World Forum for Harmonization of Vehicle Regulations**Working Party on General Safety Provisions****109th session**

Regulation No. 107 (M₂ and M₃ vehicles) –**Proposals for further amendments****Proposal for amendments to the 06 series of amendments to
Regulation No. 107 (M₂ and M₃ vehicles)****Submitted by the expert from the United Kingdom***

Figure 1

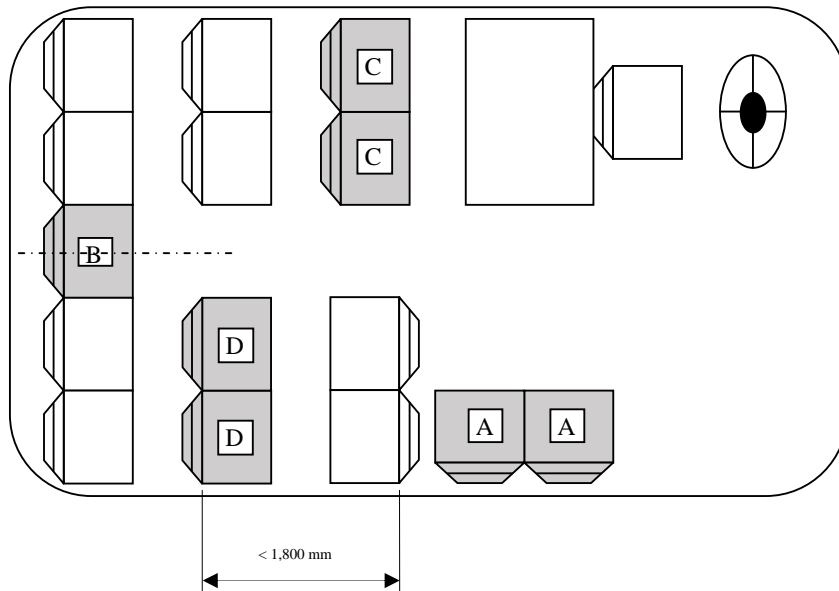
3. This proposal aims to reduce this risk by extending existing requirements for exposed seats adjacent to step wells, to apply to other exposed seats where there is a risk of the occupant being thrown forwards. New paragraph 7.12.2. exempts certain seats from these additional requirements (see also Figure 1 below).

Seats to which paragraph 7.12.2. refers to:

- A Sideways facing seat
- B Seat which has its centreline within the longitudinal projection of a gangway
- C Seat in front of which is existing vehicle structure (e.g. fixed table or luggage pen)
- D Transverse facing seats where the maximum distance between the front faces of the seat squabs does not exceed 1,800 mm

"7.12.2. **Paragraph 7.12.1. shall not apply to any sideways facing seat, a seat which has its centreline within the longitudinal projection of a gangway, a seat in front of which is existing vehicle structure (e.g. fixed table or luggage pen) offering comparable levels of protection as a guard meeting the requirements of paragraph 7.12.1. or transverse facing seats where the maximum distance between the front faces of the seat squabs of facing seats does not exceed 1,800 mm when measured in accordance with paragraph 7.7.8.4.3.**"
